© Denotes changes

APPROVED 15 May 1972 REVISED (A) 14 May 1974 (B) 25 Apr 1975 © 28 Sep 1987

P A Air Force - 85 Other Cust Army - ER Navy - AS	International Interest	TITLE SWITCH, TOGGLE, FOUR POLE, ENVIRONMENTALLY SEALED, INTEGRATED WIRE TERMINALS	MILITARY STANDARD MS27786
Procurement Specification MIL-S-3950		SUPERSEDES	PAGE 1 OF 3

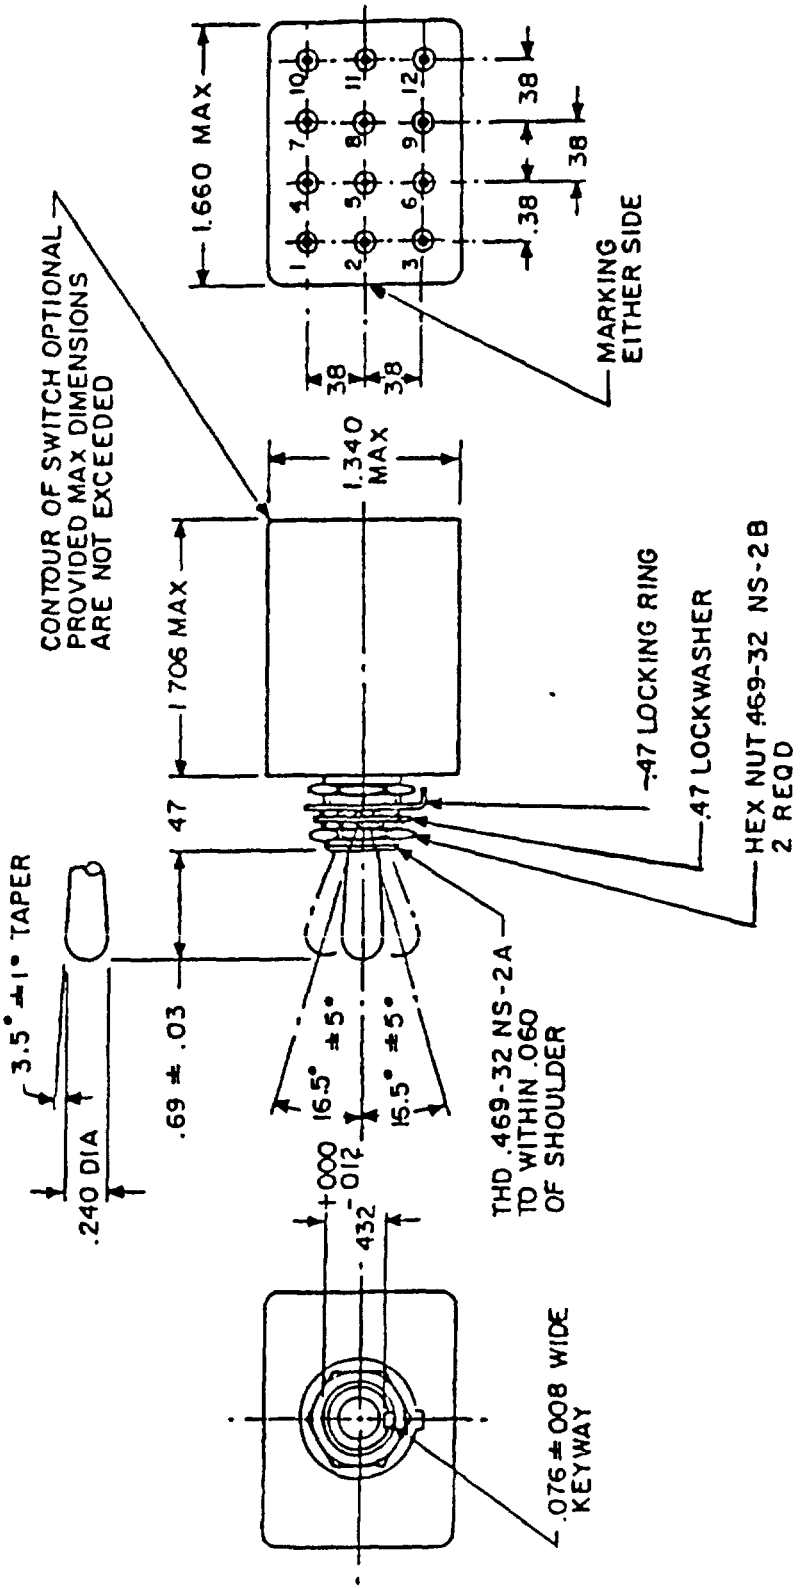
4. For hardware detail specifications see appendix of MIL-S-3950.
5. (C) Contact installing/removal tool in accordance with M81969/14-02.
6. (C) Grommet sealing plug, in accordance with MS27488A20.

7. The sealing grommet shall seal on a smooth wire insulation of .040 (1.02 mm) to .083 (2.11 mm) diameters.
8. (C) Terminal shall adequately accept a wire contact within dimensional limits of M39029/1-101

11. Sealing plugs may be used in nonfunctional grommet holes.
12. Maximum weight is .21 pound.
13. (C) In the event of a conflict between the text of this standard and the reference cited herein, the text of this standard shall take precedence.

14. (C) Referenced Government documents of the issue listed in that issue of the Department of Defense Index of Specifications and Standards (DODISS) specified in the solicitation form a part of this standard to the extent specified herein.
